**SAN ANTONIO WATER SYSTEM  
REGIONAL CARRIZO PROJECT  
BUCKHORN WELLFIELD COLLECTION PROJECT  
SAWS JOB NO. 03-8518-207  
SOLICITATION NO. B-12-021-DB**

**ADDENDUM NO. 1  
MAY 4, 2012**

Sheet 134 of 160

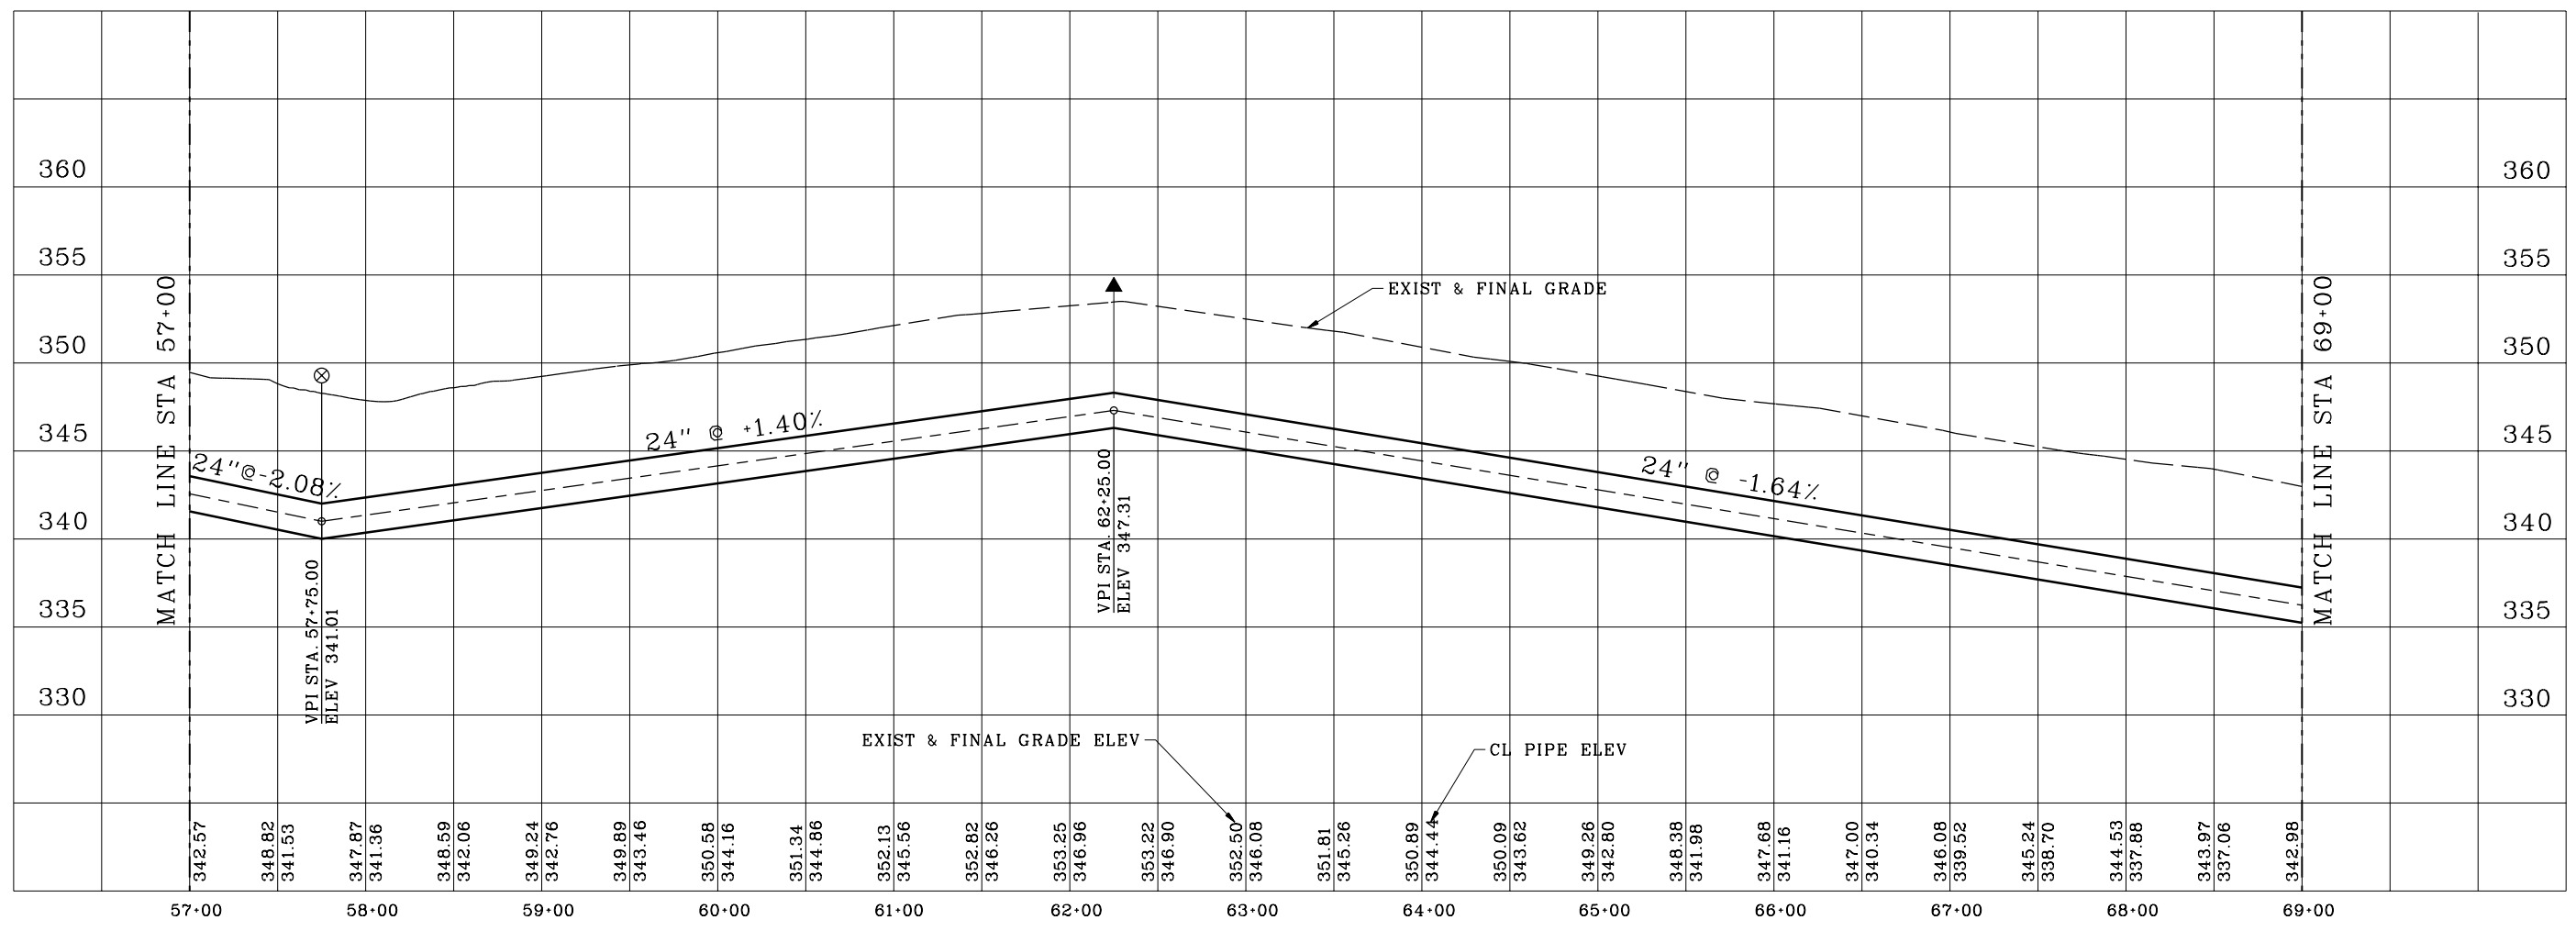
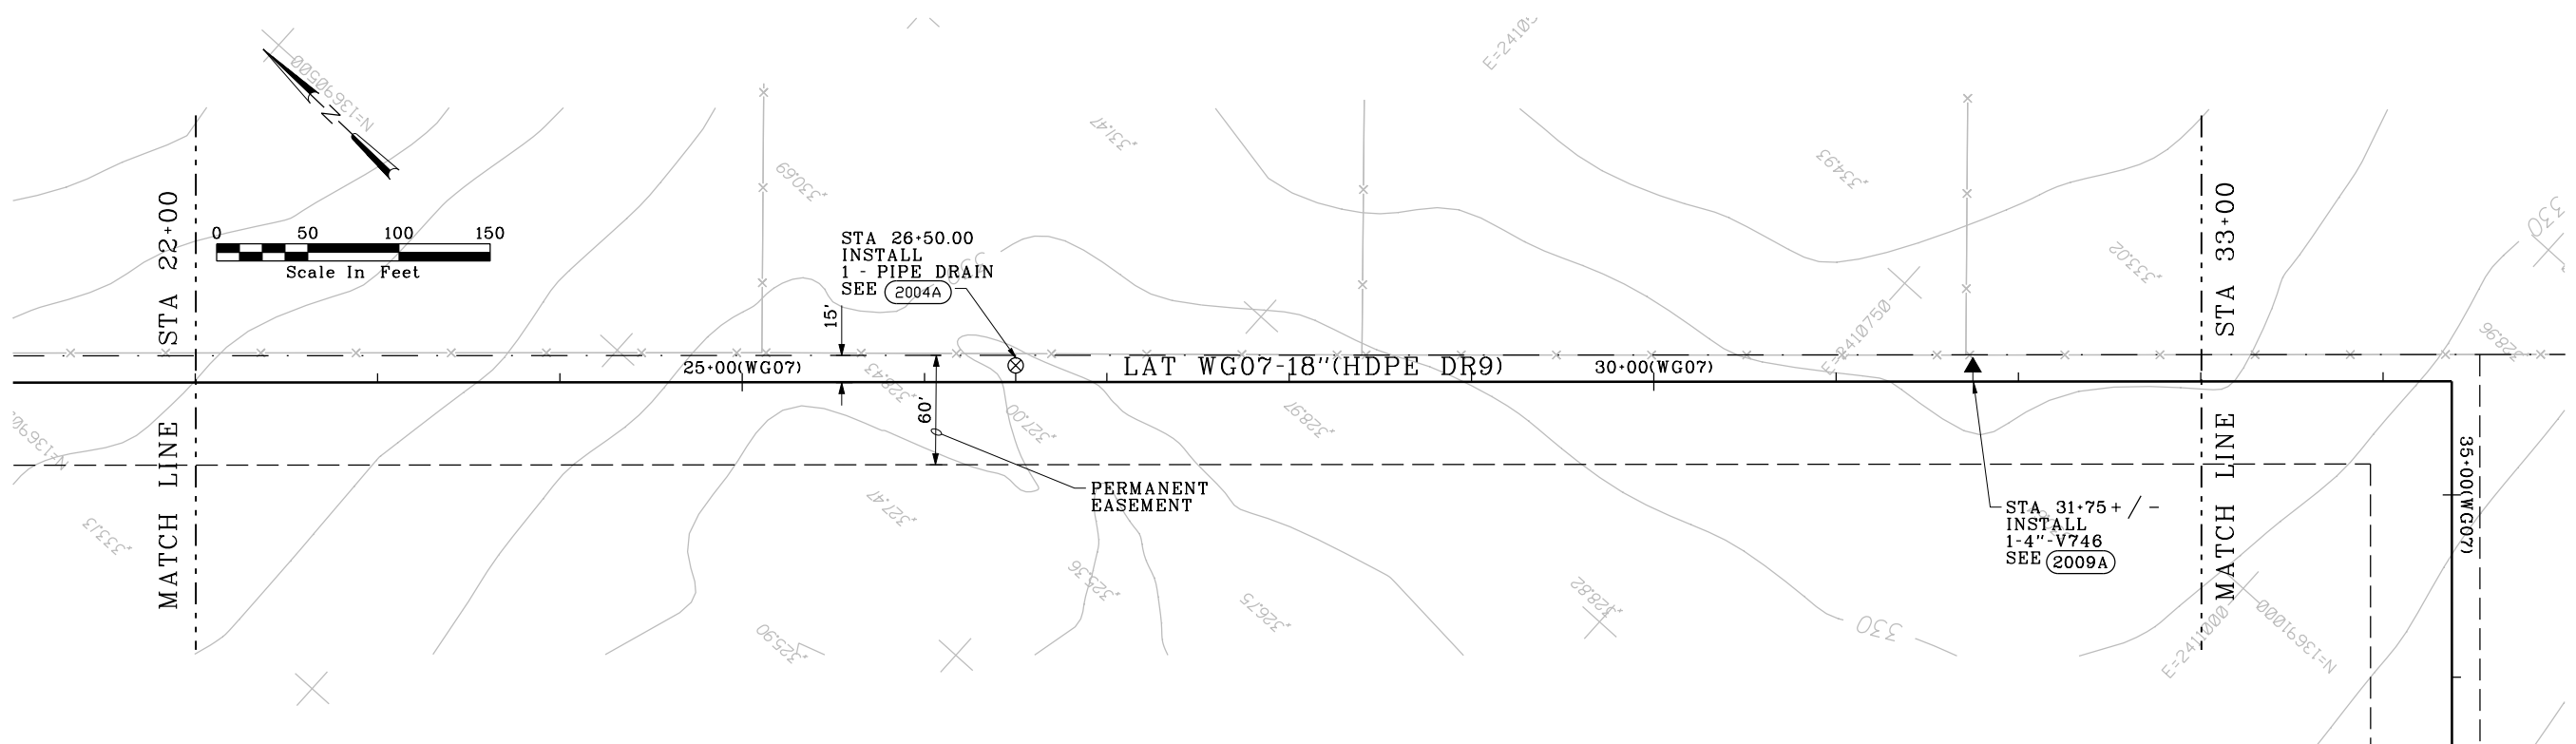
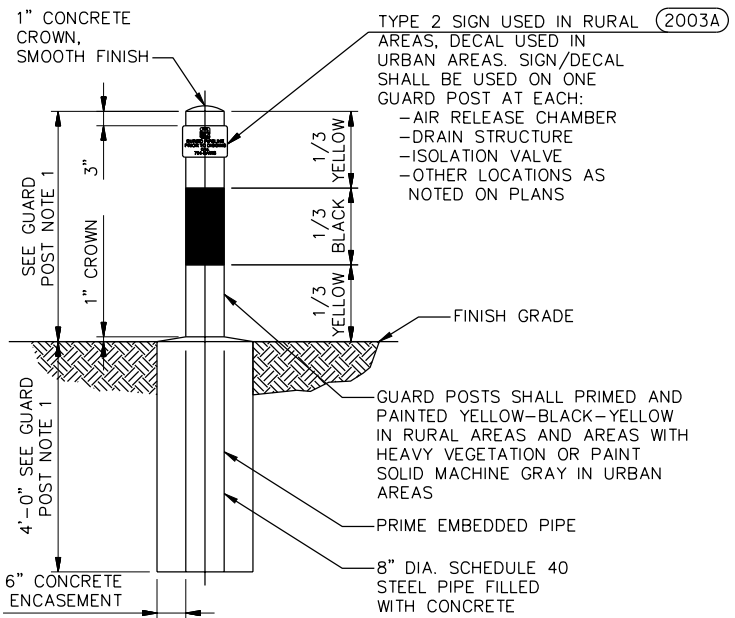
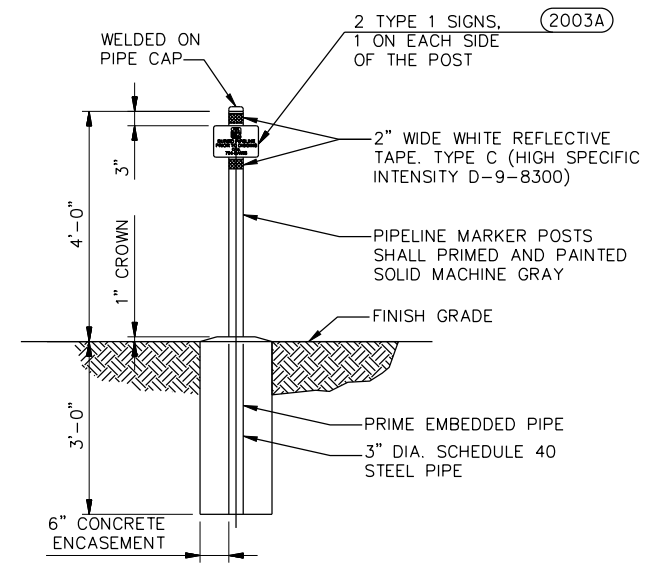
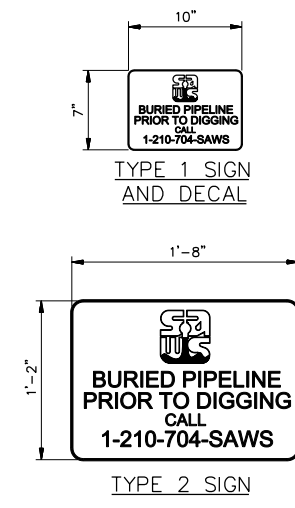
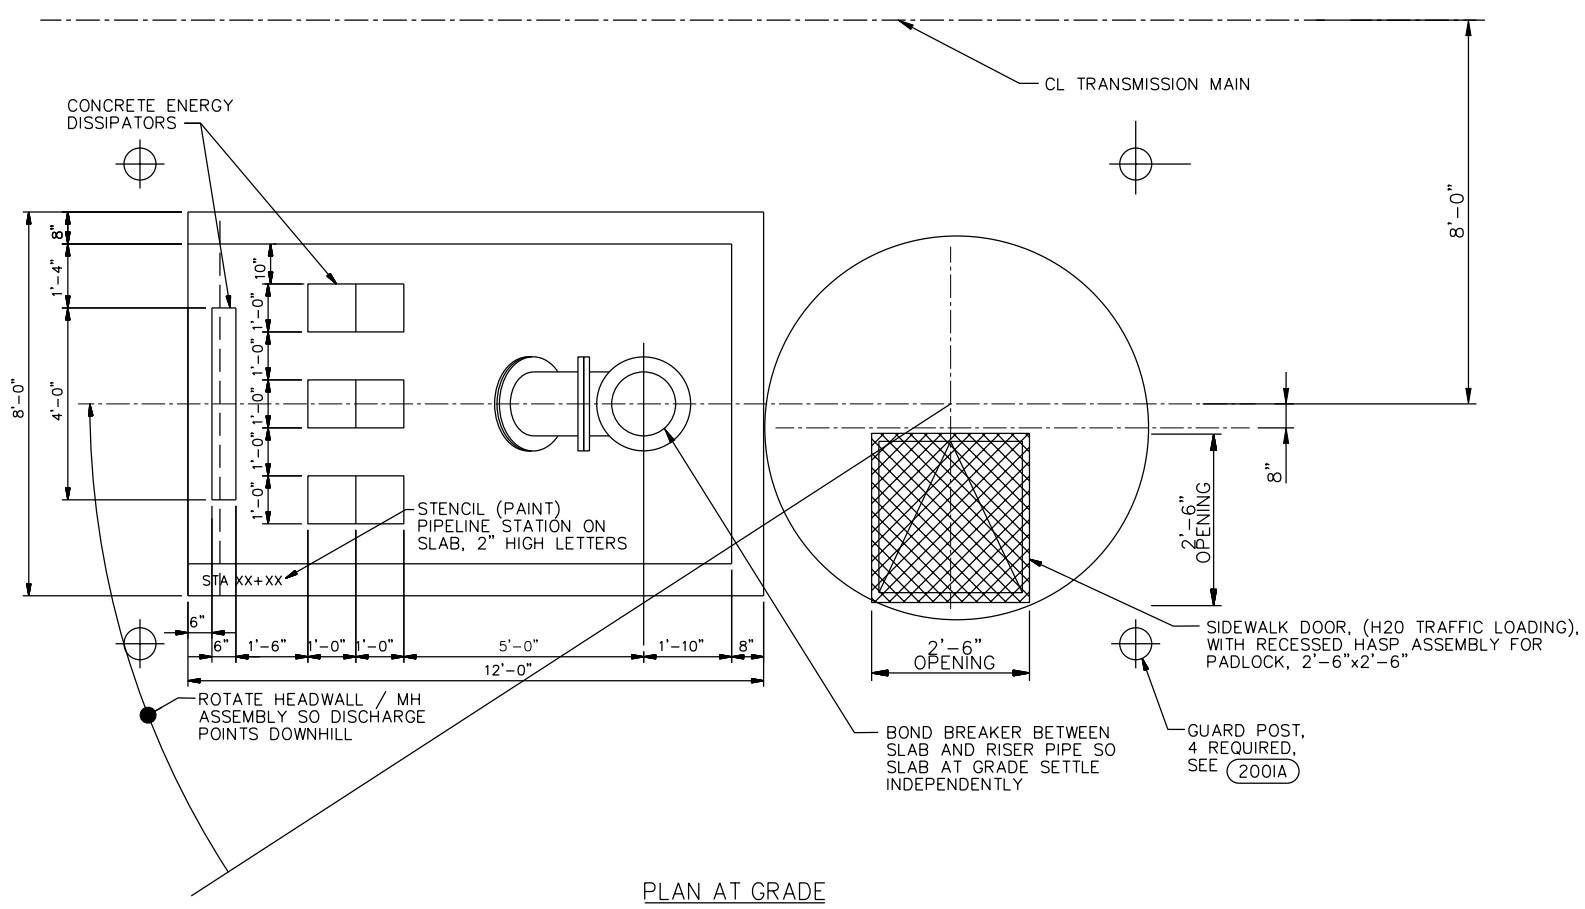
21. SHEET 134 of 160, CIVIL STANDARD DETAILS: REPLACE this sheet in its entirety.
22. SHEET 134A of 160, CIVIL STANDARD DETAILS: ADD this sheet.
23. SHEET 137 of 160, CIVIL STANDARD DETAILS, DETAIL 2009A: ADD note "8. Provide dual combination air release valves, each connected to same vent pipe, for all V741 valves as specified."

PIPE DRAIN STRUCTURE TYPE 1, STD DETAIL 2004A MOVED TO SHEET 134A
